No. EL/3.2.1/Radiator

**SPECIAL MAINTENANCE INSTRUCTION NO. RDSO/2014/EL/SMI/ 0279  
(REV. '0') --dated 24.01.2014**

Removal of orifice ring provided in the inlet & outlet flanges of Converter Oil Cooler(COC) and Transformer Oil Cooler(TOC) of 3-ph oil cooler assembly manufactured and supplied by M/s Apollo.

## **ANNEXURE**

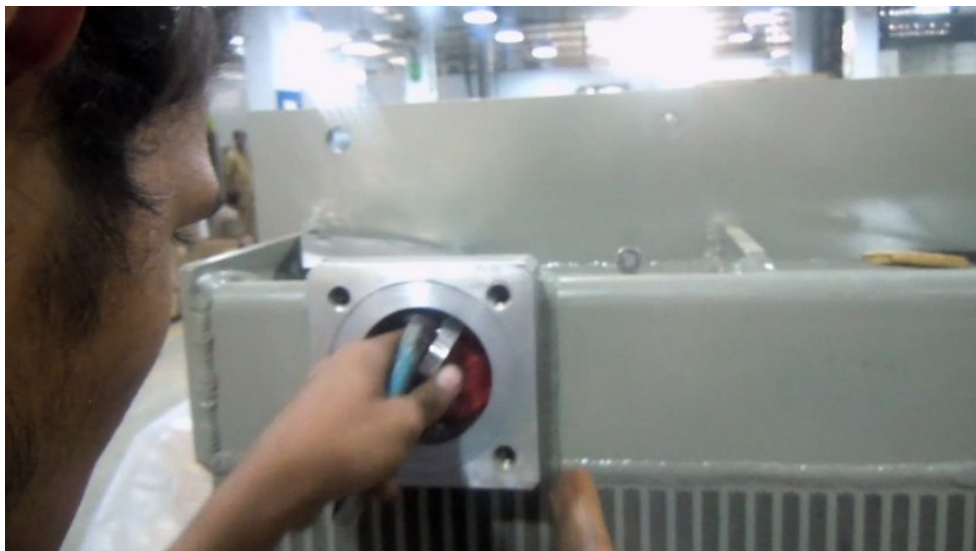
STEP 1) Chip off weld tacks 4 Nos. using chisel as illustrated in the picture. First weaken the tag by chiseling out partially weld material on the flange. Then chip off complete tag. You may put small paper inside to collect all chips and prevent them from going inside the cooler.

Step 2) Remove the orifice ring by very light hammering such that it does not damage the flange.

Step 3) Remove again remaining welding material using chisel.

Step 4) Remove the burrs and finish by half round file and / or polish paper.

Precaution: 1) Flange should not get damaged while working with half round file and/or chisel. 2) Burrs should not enter in the oil passage. 3) Carefully take paper out from inside collecting all chips. No chips should fall inside while removing paper.
